*STP-209-1(2) Roadway and BHF-209-1(3) Bridge  
Widening of SR 74 From SR 85 to*

*P.I. Nos. 322355 and 322357*

**Value Engineering Study Report**

Preliminary Design Stage

ALTERNATIVE No.  
8  
ORIGINAL DESIGN  
SHEET 4 OF 9

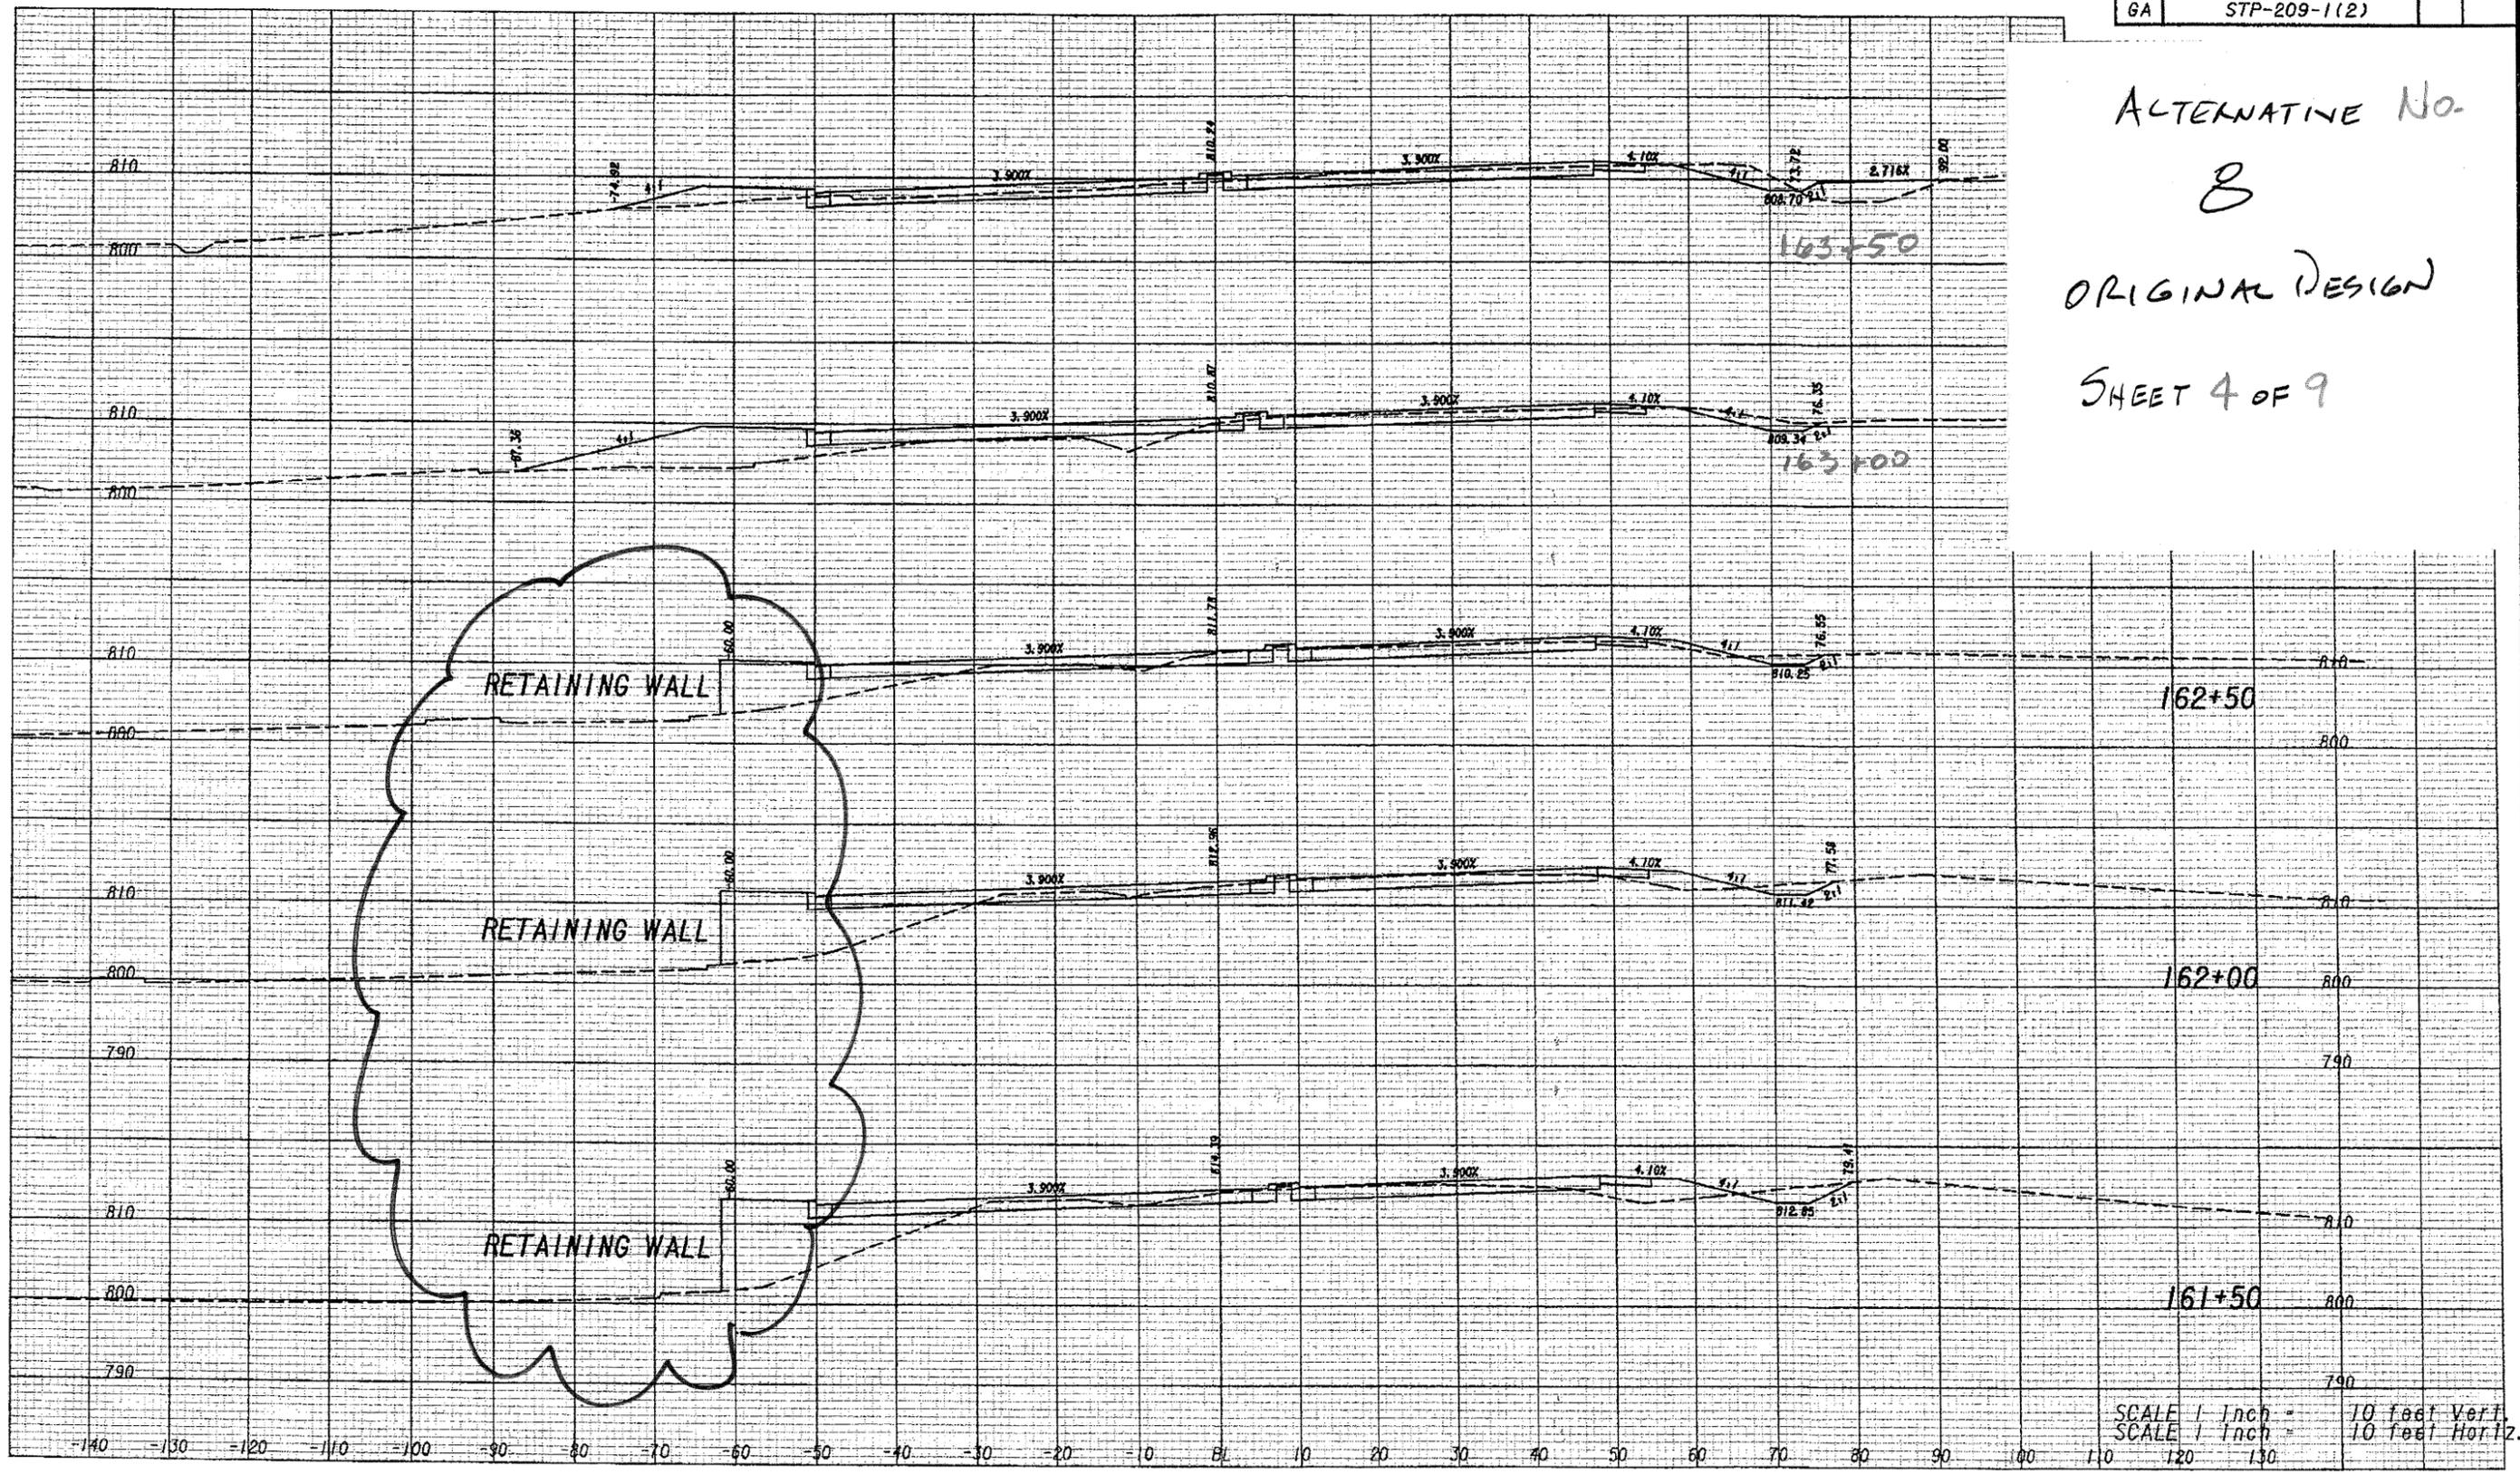
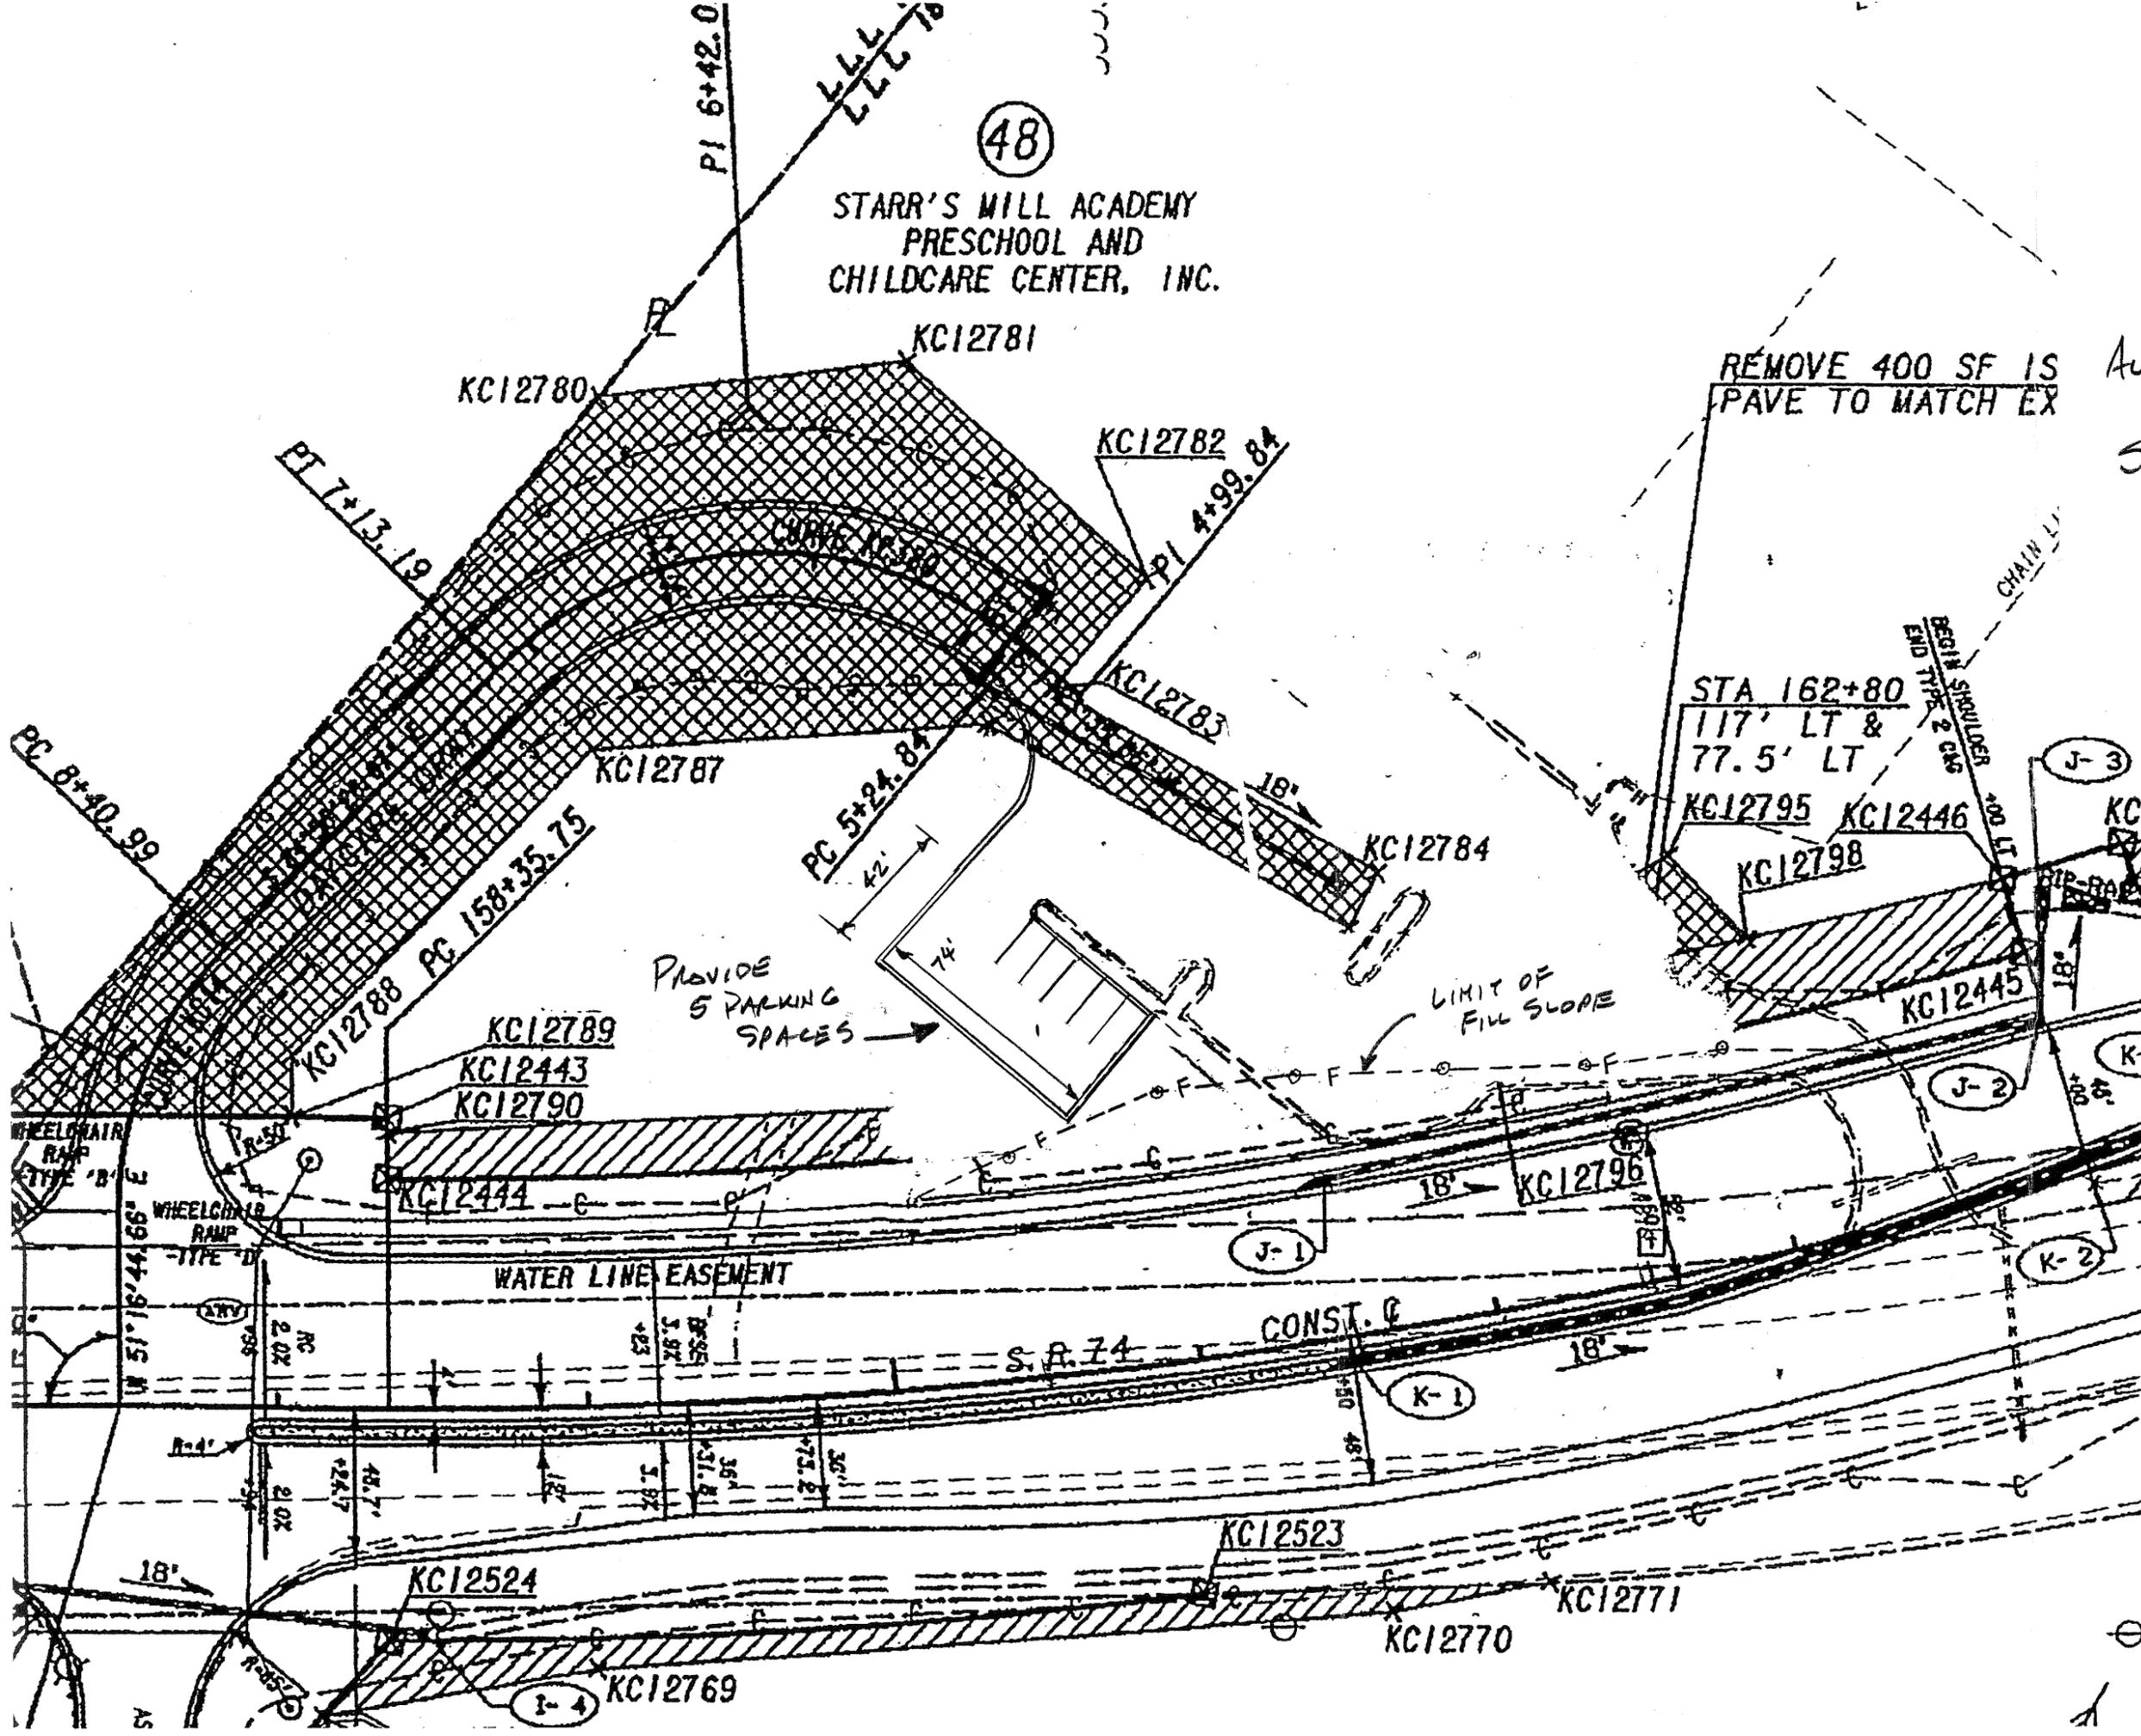
DESCRIPTION: **ELIMINATE THE RETAINING WALL AND PROVIDE** SHEET NO.: **1 of 9**  
**ADDITIONAL DAYCARE PARKING**

Replace the retaining wall with a 2:1 fill slope and provide five additional parking spaces.

PROVIDE  
5 PARKING  
SPACES
